Assessment of Nineteen (19) Protected and Non-Protected Size Trees at and adjacent to

**400 Carlton Avenue
Los Gatos, California**

Prepared for:
Mr. Sean Mullin, Associate Planner
Town of Los Gatos Community Development Department
110 E. Main Street
Los Gatos, CA 95030

Report by CTA
Version: 2/23/2017

3.0 Tree Location & Protection Fence Map

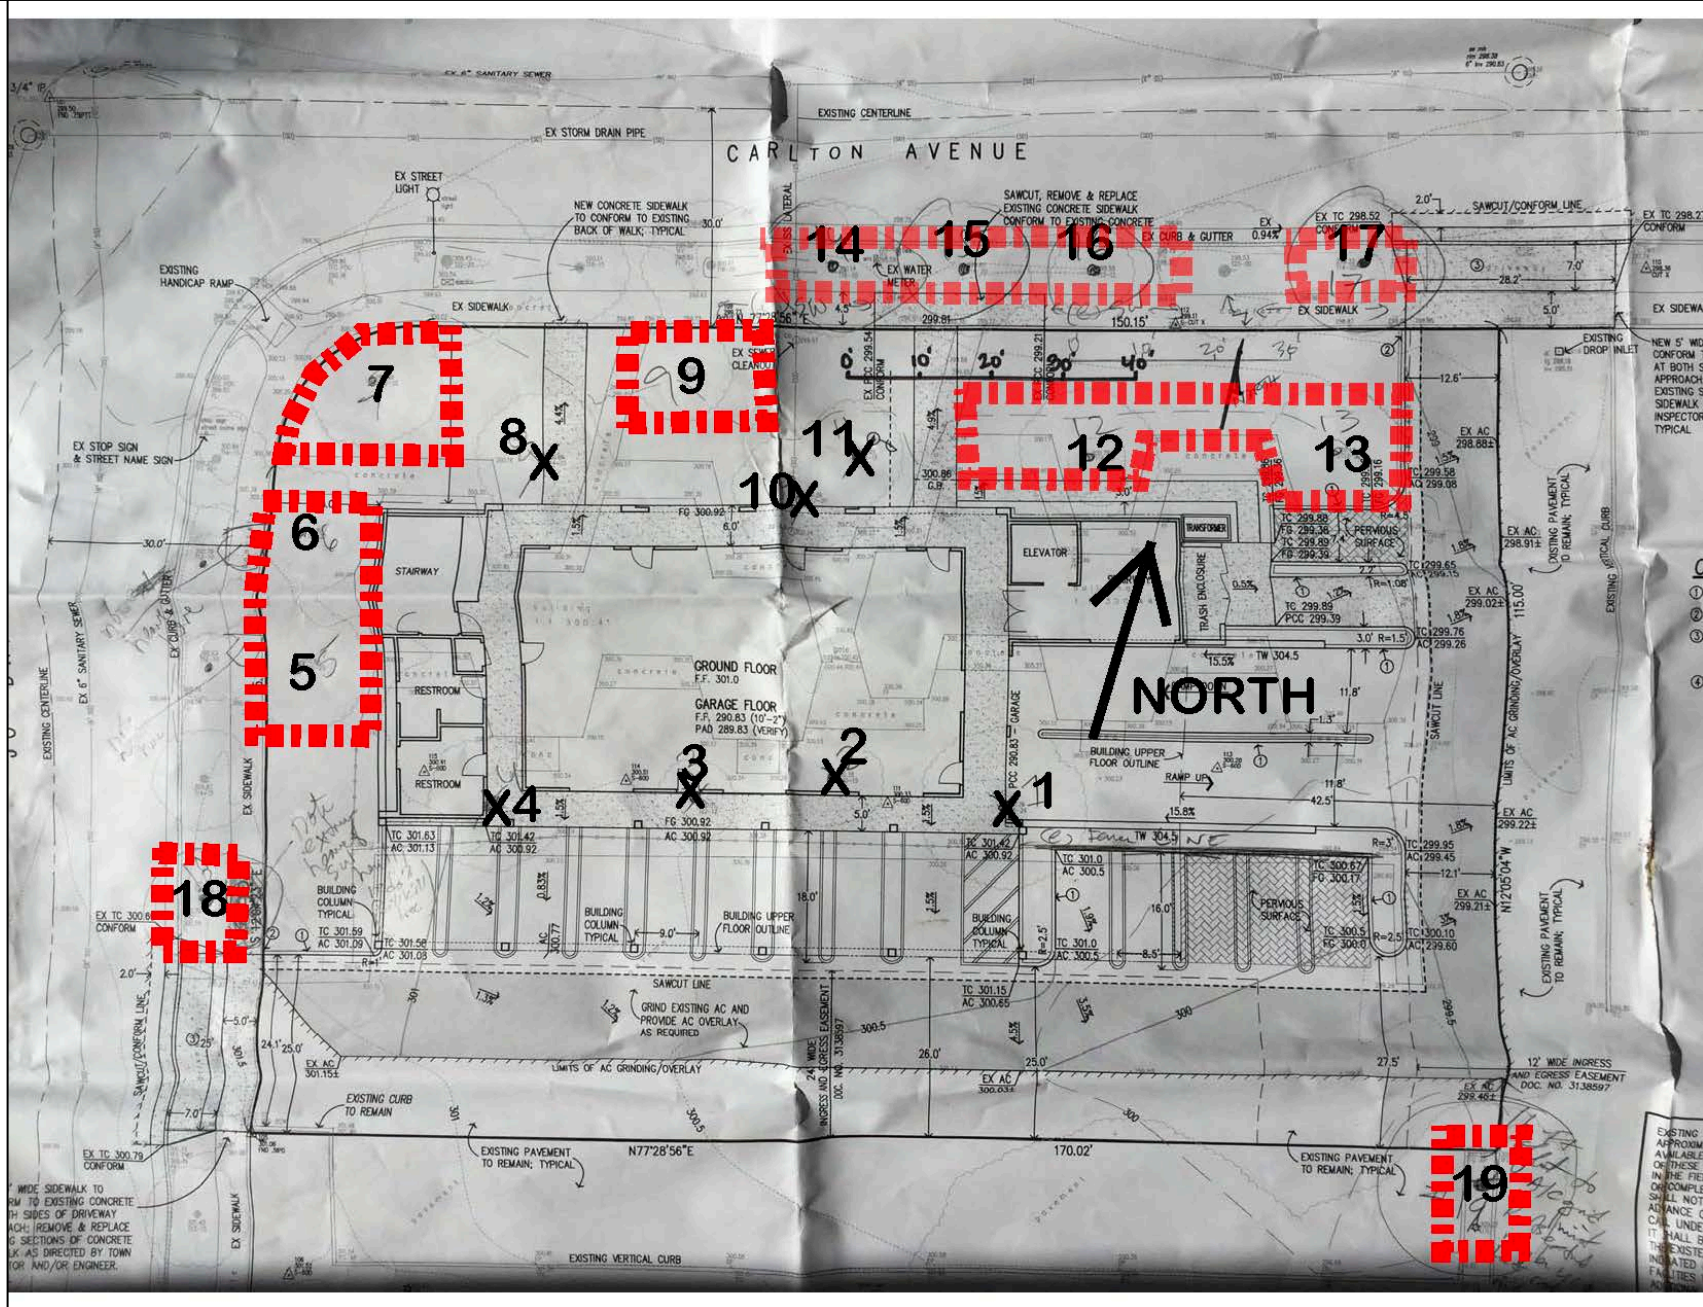
The CTA marked up the applicant's grading and drainage plan sheet dated 1/17/2017 by Hanna-Brunetti of Gilroy, California.

The **red dashed lines** indicate the CTA's suggested chain link root protection fence alignment (initial rough), based on available remnant root zone areas that are protectable (assuming the scope of site plan work will occur as currently proposed).

Note that the red dashed lines are shown as root zone protection fence routing around both non-protected size trees and protected size trees being retained.

The project team can choose to ignore protection for non-protected size olives #9 & #13 at their discretion.
